# SERVICE BULLETIN

SUBJECT: RETRACT SAFETY MICROSWITCH REPLACEMENT (MODIFICATION N366)

All Nomad N22-Series and N24-Series aircraft whose log books do not already record the embodiment of Mod N366 of compliance with Service Bulletin NMD-32-12.

Installation of Landing Gear Retract  
Safety Switch Assembly  
Figure I

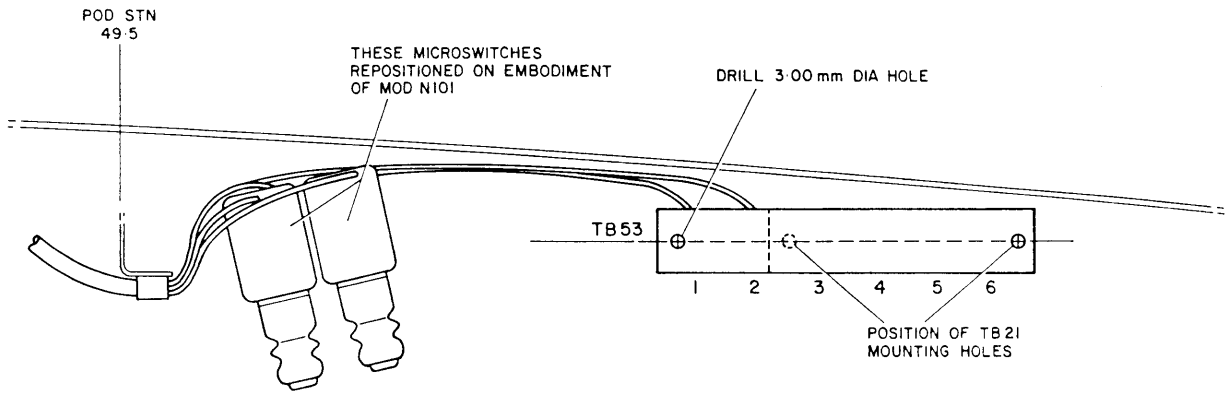
The existing retract safety microswitch is replaced by an hermetically-sealed microswitch to prevent the ingress of moisture and dirt.

A new microswitch and mounting bracket is fitted to the LH main gear oleo leg upper torque link assembly and a new terminal board fitted to the LH wheel pod wall.

- F. Remove brackets P/N 1/N-40-648 and P/N 1/N-40-649 from upper torque link assembly of LH main gear oleo leg.
- (1) Drill out rivets P/N MS20470AD4-6 securing bracket P/N 1/N-40-649 and remove and discard bracket.

- (2) Remove and discard bracket P/N 1/N-40-648 and attaching parts, screws P/N MS35206-229, self-locking nuts P/N MS21083-N06 and washers P/N AN960-PD6.

- G. Secure bracket P/N 1/N-40-934 to the upper torque link using screws P/N MS35206-217, washers P/N AN960-4 and self-locking nuts P/N MS21083 N04.
- H. Fit new retract safety switch assembly P/N 1/N-81-694.

- (1) Secure microswitch to bracket P/N 1/N-40-934.
  - (2) Secure cable loom to hydraulic brake pipe on main gear oleo leg using tiedown straps P/N MS3367-5-9.

Installation of TB53 in LH Wheel Pod  
Figure 2

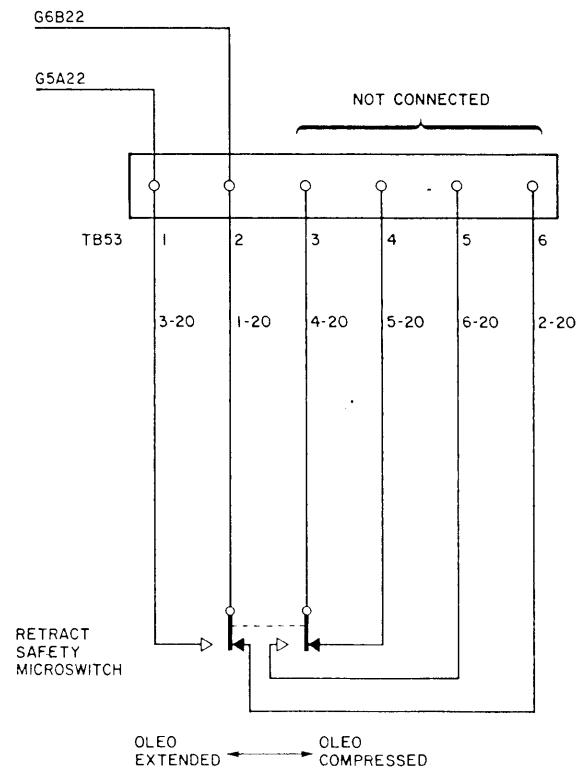
- E. Fit new terminal board TB53 P/N MS27212-1-6.
- (1) Remove TB number and terminal idents from the wheel pod wall.
  - (2) Locate the position of the forward fixing hole for the new terminal board (Ref Figure 2) and drill a 3.0 mm dia hole in this position.

- (3) Secure the new terminal board using the screws P/N MS35206-216, retained in Para 2.C. and new self-locking nuts P/N MS21083-DO4.
  - (4) Paint the TB number and terminal idents in black characters 0.125 inches high on the wheel pod wall in the positions shown in Figure 2.
